Consists of information furnished in response to NRC staff questions concerning applicant's Appendix I submitted on June 4, 1976 re the Turbine Building Exhaust System..... with attached drawings.....

Re: Oconee Nuclear Station
Docket Nos. 50-269,-270,-287

RESPONSE TO REQUEST FOR ADDITIONAL INFORMATION ON 10CFR50 APPENDIX I

KEY PLAN
ARCHITECTURAL

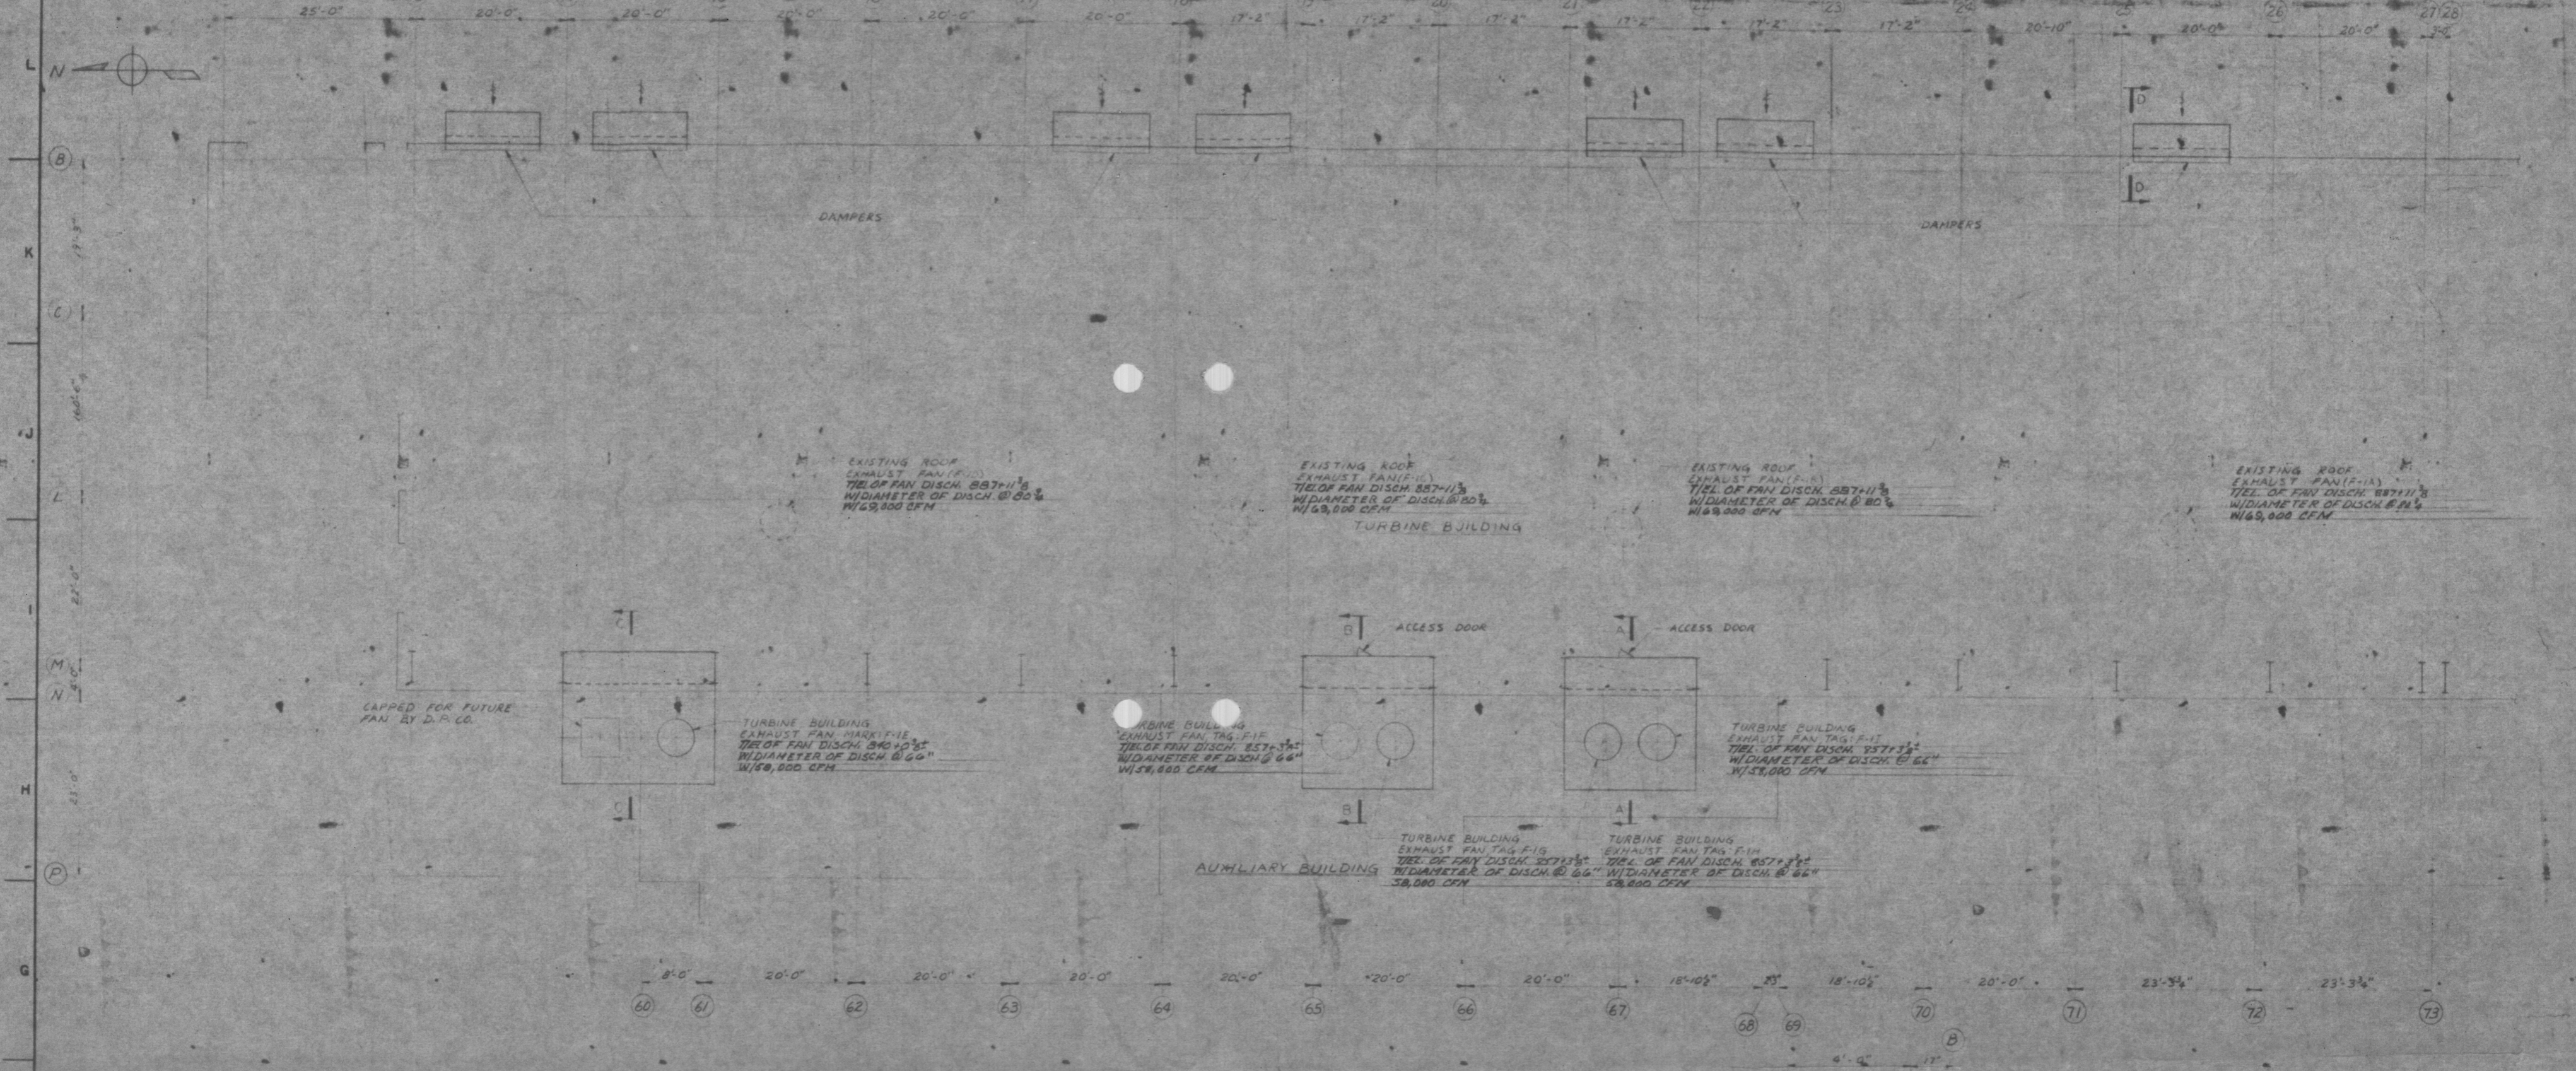
1. Question - Provide the description of the Turbine Building Exhaust System, including flow rate, velocity, height above grade, height above and relative location to adjacent structures, relative temperature difference between exhaust effluent and ambient air, and size and shape of the flow orifice.

Note: All fans are arranged "in-line," running North - South. All locations given are from the center of this line; i. e., center of Turbine Building, Unit 1, North - South dimension. See attached drawings for additional details.

- a) 4' East of Unit 1 & 2 Auxiliary Building and 30 feet above it.
 - b) 45' East of Unit-1 Reactor Building and 99 ft below it.
 - c) 225' NE of Unit-2 Reactor Building and 99 ft below it.
 - d) 450' NNE of Unit-3 Reactor Building and 99 ft below it.
 - e) 225' SE of Administration Building and 64 ft above it.
 - f) 185' SW of Service Building and 62 ft above it.
